CALIFORNIA ENERGY COMMISSION

**RE: PALMDALE HYBRID POWER PROJECT (PHPP) (08-AFC-9)
DATA REQUEST SET 2 (#s 91-156)**

California Energy Commission DR22
Figure 1

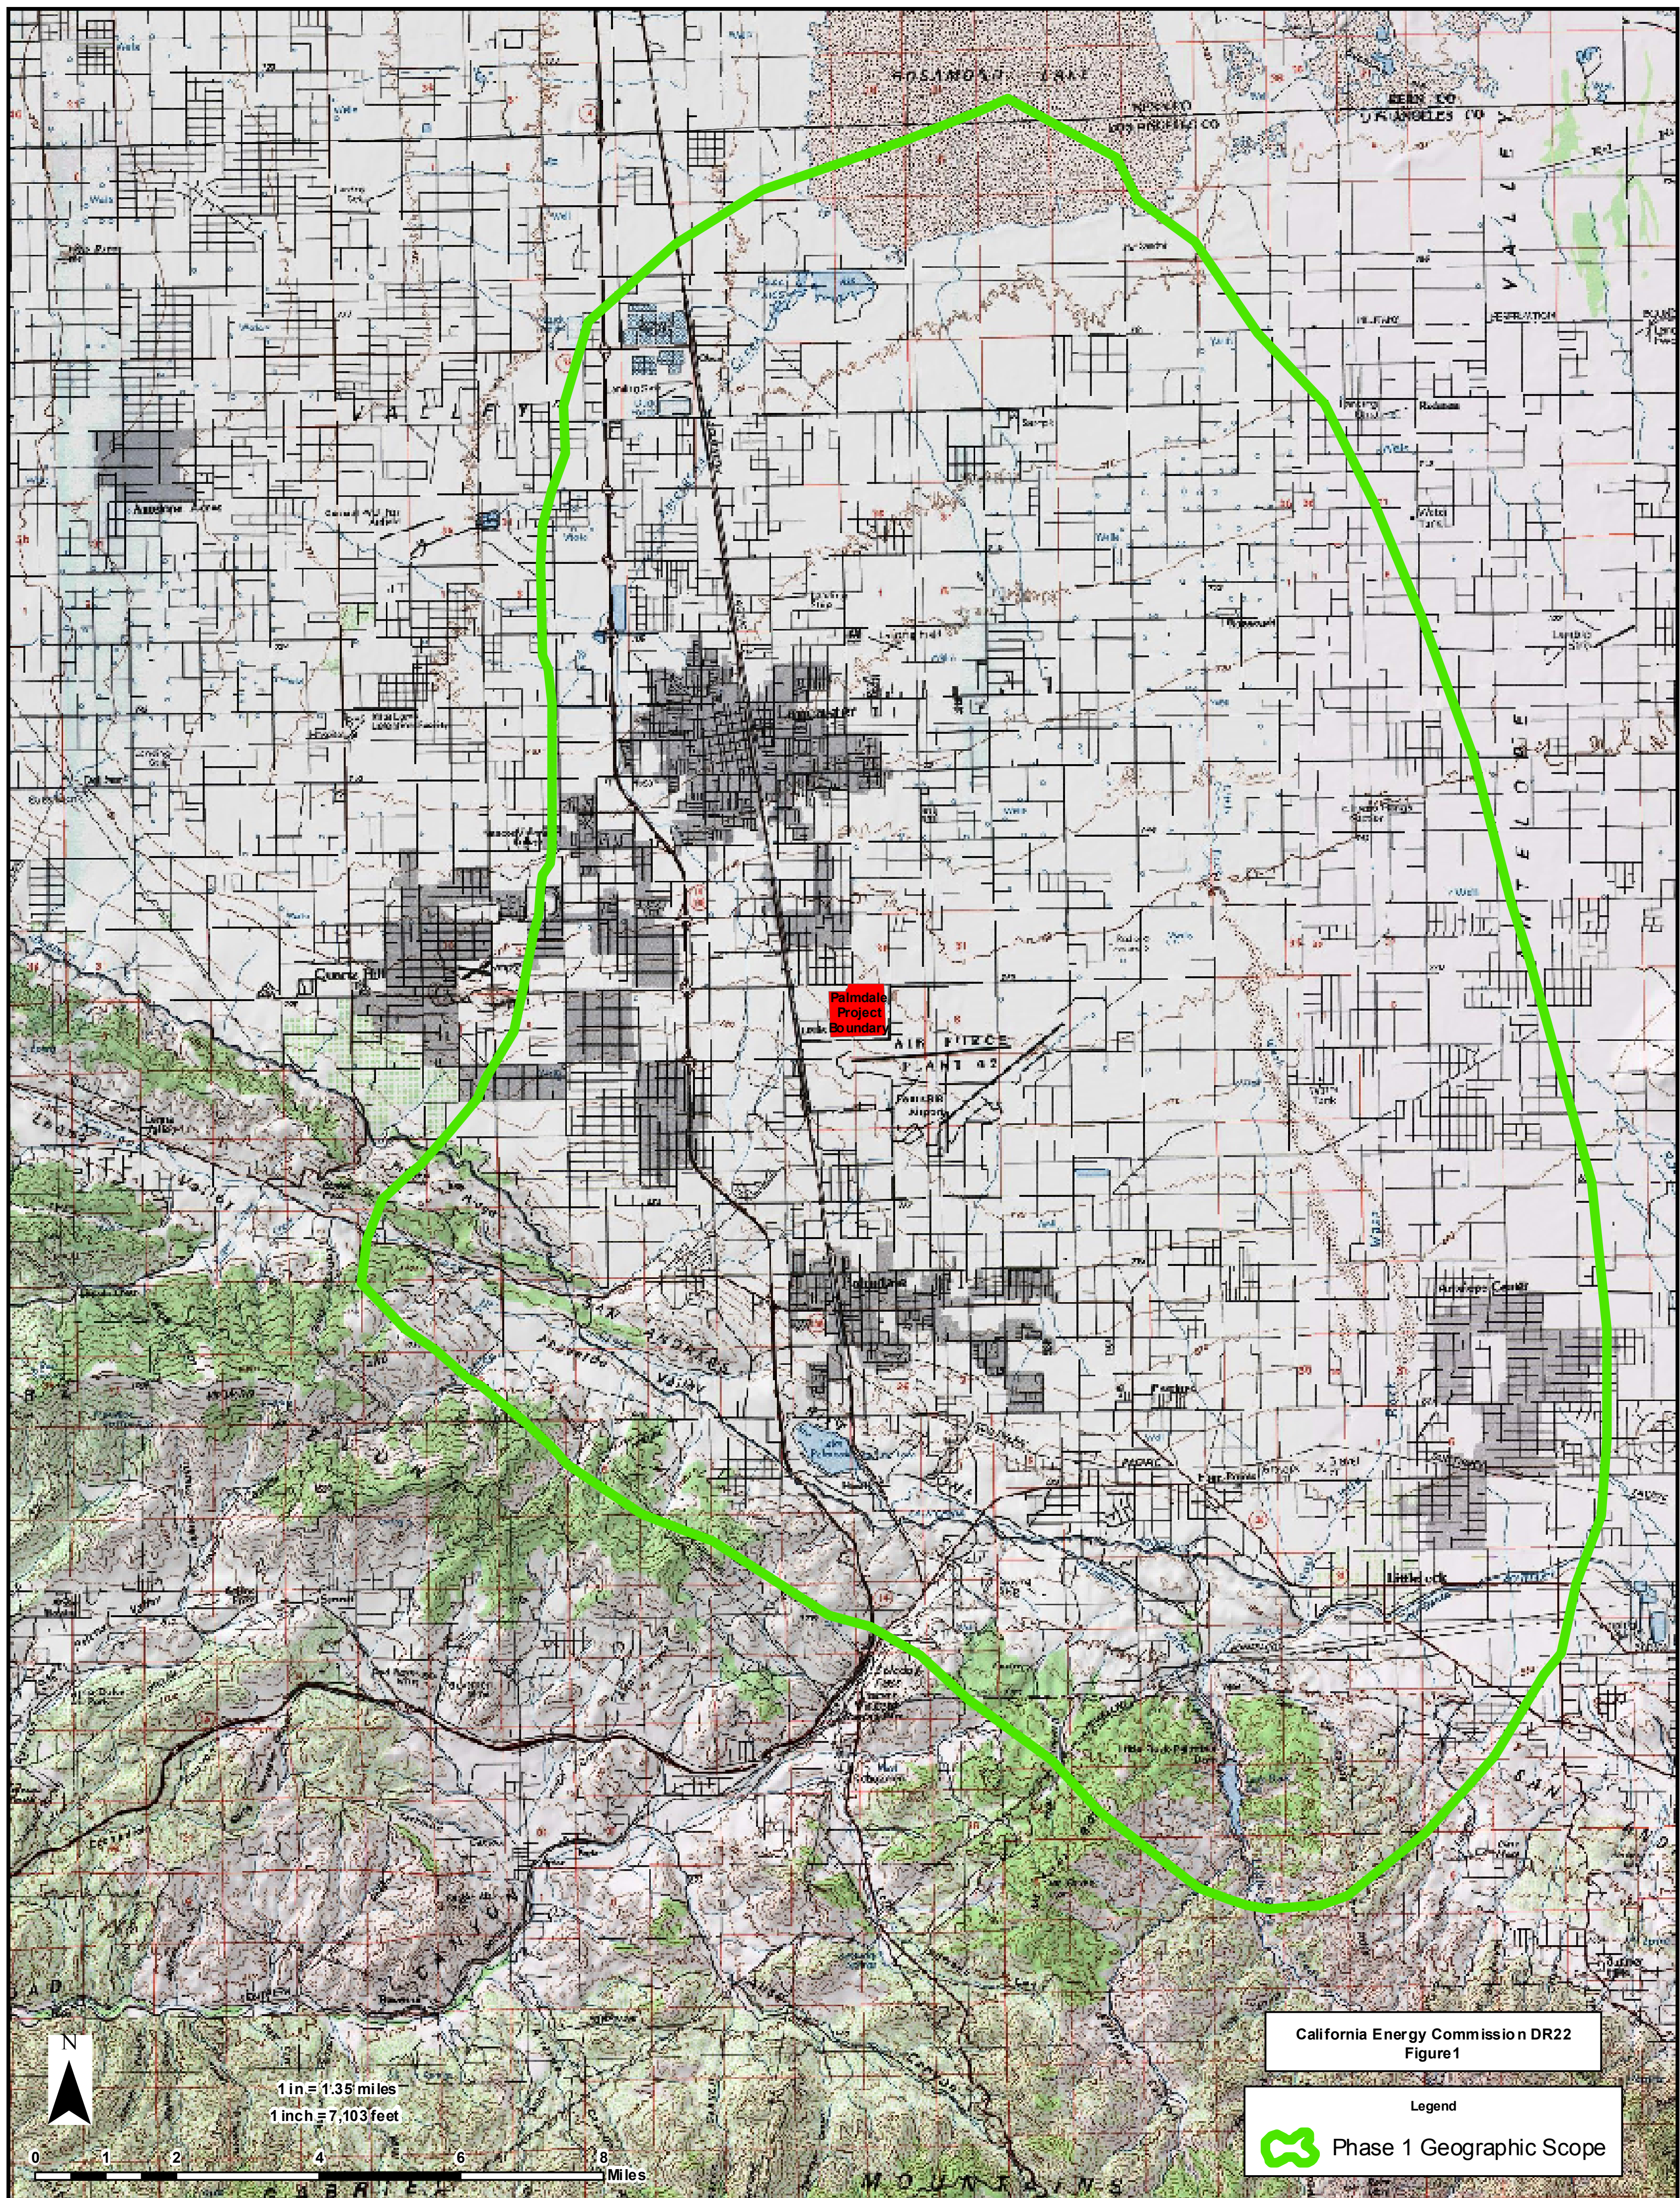
The specific area for which staff is requesting a “big picture” summary is outlined on the attached figure (Energy Commission DR22 Figure 1). It is necessarily large to include the project site’s landform and those nearby landforms with which it has a historical geomorphic relationship. So the Phase 1 study area includes:

- the source of and the transporting vectors for the project site’s sediments—the San Gabriel Mountains and the canyons in the foothills of the San Gabriel Mountains to the south and southwest;
- the project site’s landform—the merged alluvial fans forming a bajada extending to the northwest and southeast; and
- the landform of the proposed project’s most extensive component, the transmission line—the slightly sloping plain to the north and northeast

dissected by numerous shallow washes, which further drain the two higher landforms.
